# Planning and Development Reports

**Committee Consideration – 10 June 2014**  
**Council Resolution – 24 June 2014**

<b>PD19.14</b>	<b>No. 16 (Lot 49) Loch Street, Nedlands - Proposed Two-Storey Single House</b>
----------------	---

**Council refuses an application for a two-storey single house at No. 16 (Lot 49) Loch Street, Nedlands, in accordance with the application and amended plans received on 24 April 2014, for the following reasons:**

Figure 3 – Ground Floor Windows Screened

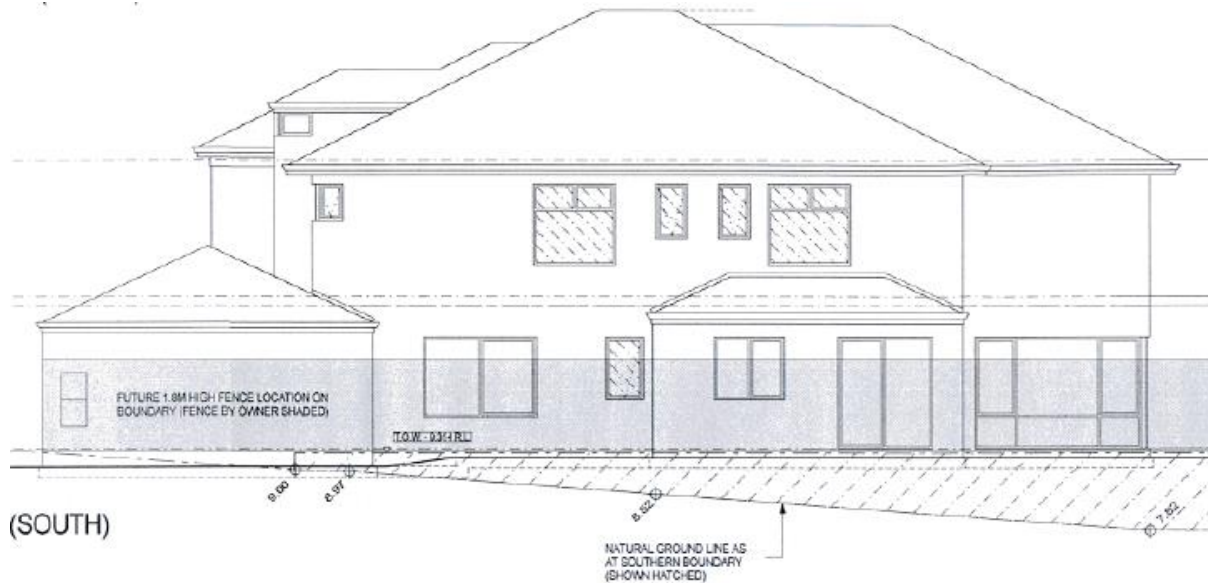
In response, the neighbouring property has three Major Openings and an Outdoor Living Area that need to be carefully considered. Noting that there are no visual privacy variations due to a 1.8m fence being proposed (above the subject site's proposed ground levels), obscuring the windows will not decrease the impact of bulk upon the neighbour (see Figure 3 below from Attachment 1).

The overall overshadowing upon the neighbouring property complies (less than 25 per cent); and these walls cannot cast any shadow due to overshadow of the upper floor (with a compliant wall setback). Therefore, the overshadowing felt and access to sunlight will not be assisted by increasing the setbacks of these walls.

Objections from the neighbour have been received, however given the above they are not supported.

In addition to this, the lower floor wall setbacks could be made to comply with the deemed-to-comply standards, by the following modest design changes:

- Dining room wall setback increased from 3.65m to 4.2m;
- Kitchen room wall setback increased from 1.0m to 1.1m; and
- Kitchen and Theatre room windows being obscured.

Figure 4 – Ground Floor Windows Screened & Upper Floor without Major Openings

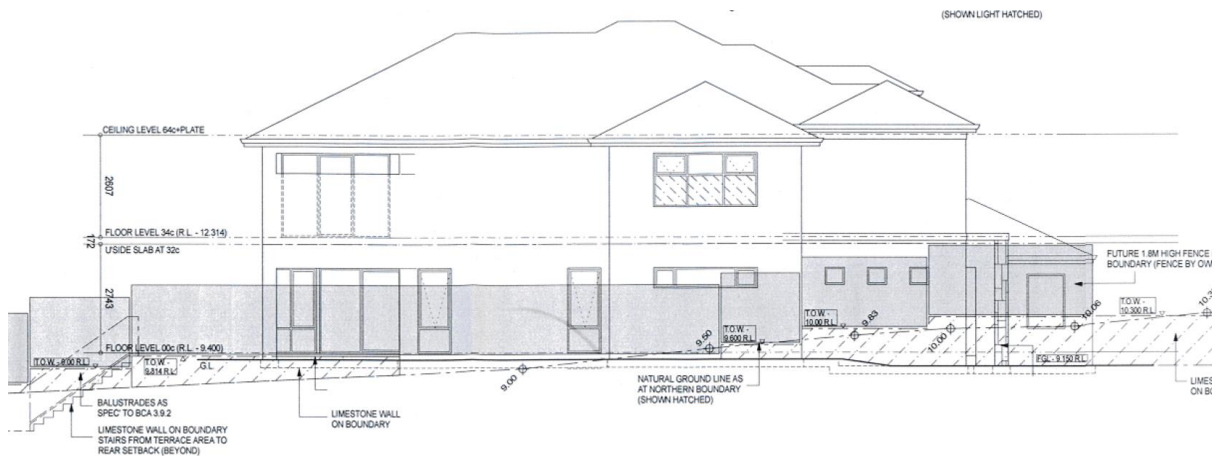
The neighbouring property has three major openings and an outdoor living area (deck) that needs to be carefully considered. There are no visual privacy variations due a 1.8m fence being proposed (above the subject site’s proposed ground levels), and no major openings proposed on the upper floor (see Figure 4 below from Attachment 1).

Therefore, obscuring the ground floor windows will not decrease the impact of bulk upon the neighbour; however setting back the upper floor will as it abuts an outdoor living area.

On the upper floor, the setback variation abuts sensitive major openings and an outdoor living area.

Objections from the community have been received, and given the above, they are supported for the upper floor.

In addition to this, the wall setbacks could be made to comply with the deemed-to-comply standards, by the following modest design changes:

- The upper floor Balcony and Sitting room wall setback increased from 1.7m to 2.1m; and
- The lower floor Family room windows being obscured.
